Applicant: BEN MULLINS OBO / EUROPEAN AUTO GARAGE**Request:** BUILDING PERMIT**Meeting Date:** 8/9/2021**Address:** 1229 Lovell Rd.**Map/Parcel Number:** 118 H A 3502**Location:** West side of Lovell Road north of its intersection with Blanket Bay Way**Existing Zoning:** CA (General Business) / TO (Technology Overlay) and A (Agricultural) / TO (Technology Overlay)**Proposed Zoning:** N/A**Existing Land Use:** Auto repair facility**Proposed Land Use:** New storage building for facility (secondary use to the vehicle repair facility)**Appx. Size of Tract:** 5.03 acres**Accessibility:** Access is via Lovell Road, a 5-lane minor arterial with a 60-ft pavement width inside a 100-ft right-of-way.**Surrounding Zoning and Land Uses:** North: A (Agricultural) / TO (Technology Overlay) and PC (Planned Commercial / TO (Technology Overlay) - Vet office and single family residences

**8-A-21-TOB
CERTIFICATE OF APPROPRIATENESS**

CONCEPT PLAN
NEW STORAGE BUILDING
EUROPEAN AUTO GARAGE
1229 LOVELL ROAD
KNOXVILLE, TENNESSEE

Figure 4 (Street View of Property)

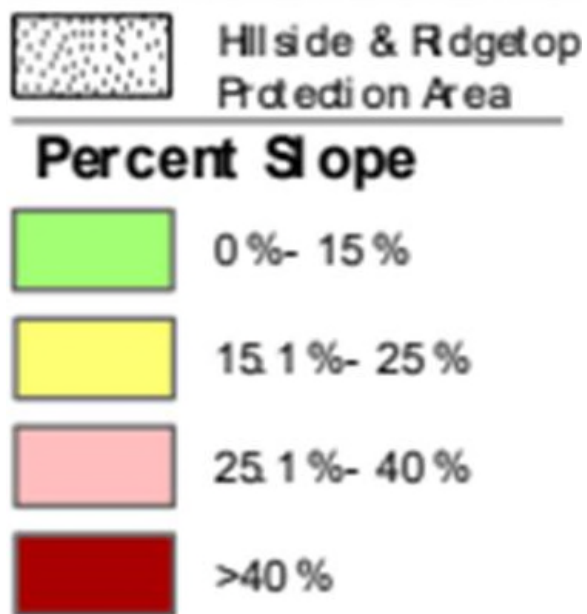
Sections 3.2.2 and 3.3.2 require landscaping to be added at the building entries. This waiver is justified because the building will not be visible from the public right-of-way (See Figure 4 Street View of Property) nor will the building's entrances be visible to any adjoining residential lots due to the existing vegetation and the landscaping plan to replace any vegetation removed with guideline and code compliant landscaping. The development is seeking a manicured Kentucky equestrian farm aesthetic and may add ornamental landscaping as desired; however, there's no justification for any landscaping to be mandated. As such a waiver of the requirements of Section 3.2.2 and 3.3.1 is appropriate.
